MONUMENT SQUARE RESIDENCES

45 Monument Square, Charlestown, MA 02129

DRAWING TITLE:
TITLE SHEET

December 6, 2021
DATE OF ISSUE
DESIGN REVIEW
DOCUMENT PHASE
As indicated
SCALE
2114.00
PROJECT #

A102

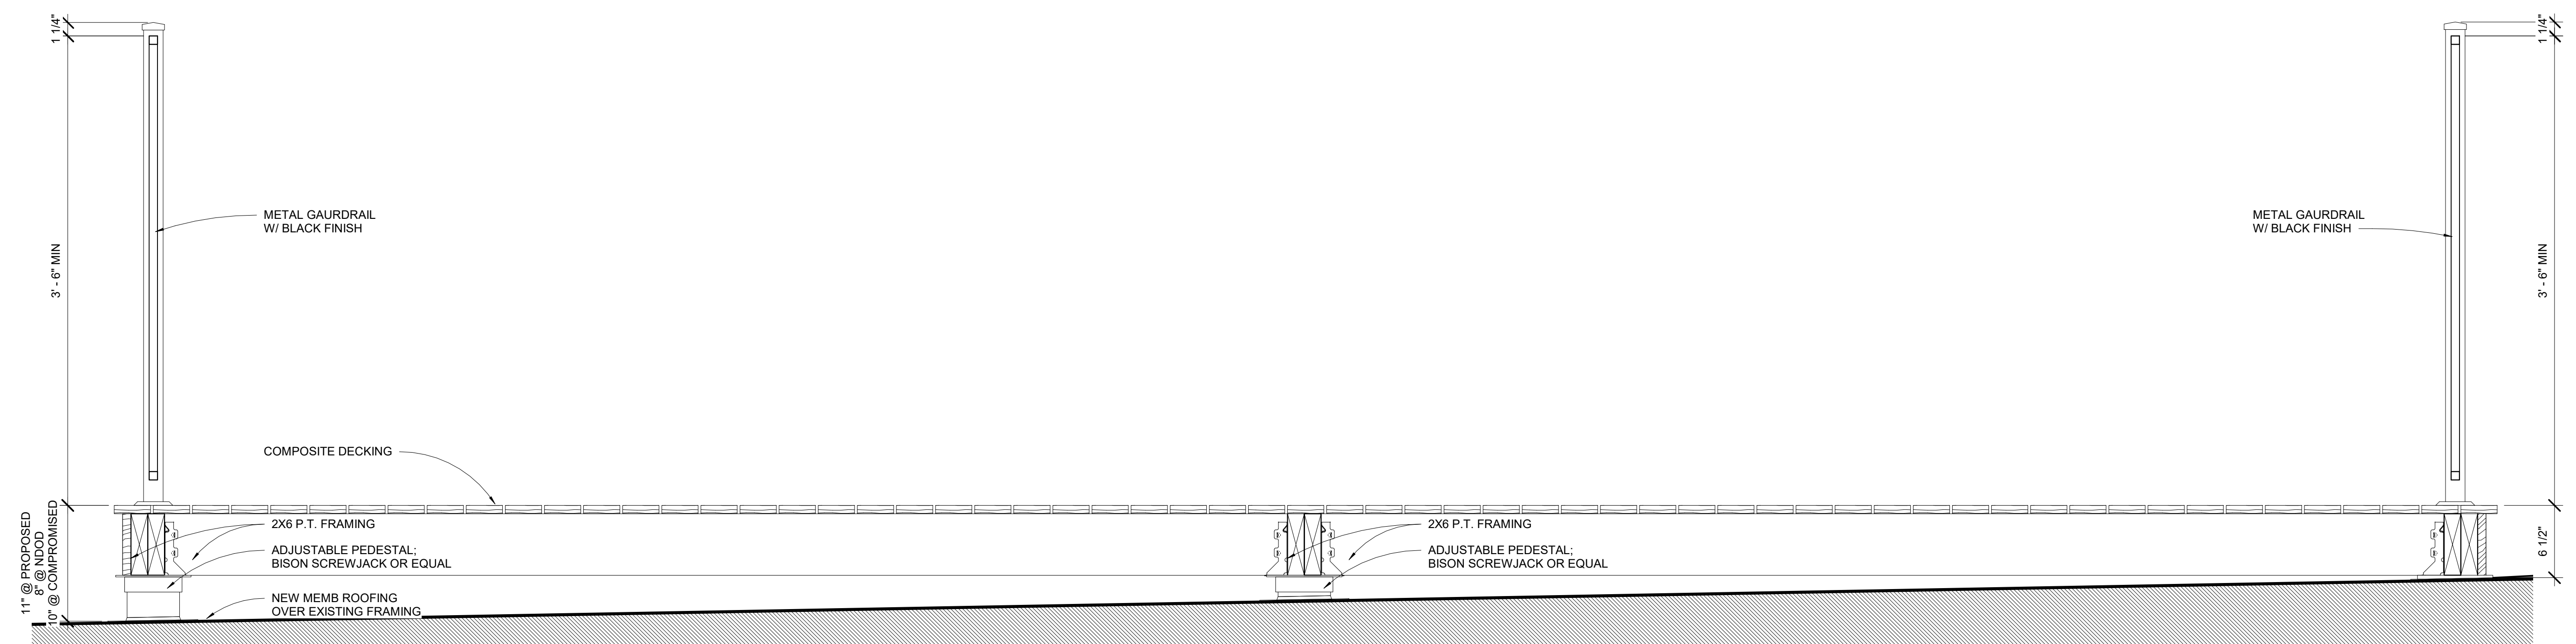
- Siding and trim: No vinyl or aluminum siding will be allowed. Clapboards shall be wood to match the historic condition. All trim (corner boards, door/window casings, soffit/fascia trim, skirt boards, frieze boards, etc.) shall be wood. All existing siding and trim shall be preserved and repaired where possible, and replaced to match existing only if necessary.

- Doors: All doors shall be wood. Metal or vinyl doors will not be allowed. Fiberglass doors may be considered as long as the detailing and finish matches wood doors and has a painted finish. All doors facing the street shall have translucent panels. The front doors shall be retained to match their historic double door entry, or shall be replaced to match existing if repair is not possible.

- Windows: Windows should be wood or wood clad in another material, such as fiberglass. Vinyl windows and metal windows will not be allowed. All windows shall have exterior muntins and half screens. All windows shall be simulated divided lite (SDL).

- All architectural detailing (cornice, frieze, architrave, dentils, etc.) shall be wood, to be preserved and repaired. If repair is not possible, they will be replaced to match existing.

- Roof deck: The roof deck shall be laid out to minimize visibility from Monument Square. The railings shall be a black metal, with an emphasis on verticality, to match existing context. Pressure treated lumber will not be allowed as an externally visible material for exterior decking. All pressure treated wood exposed to public views on the site shall be covered and shielded from view. Use of PVC, composite, and/or natural wood materials is acceptable.
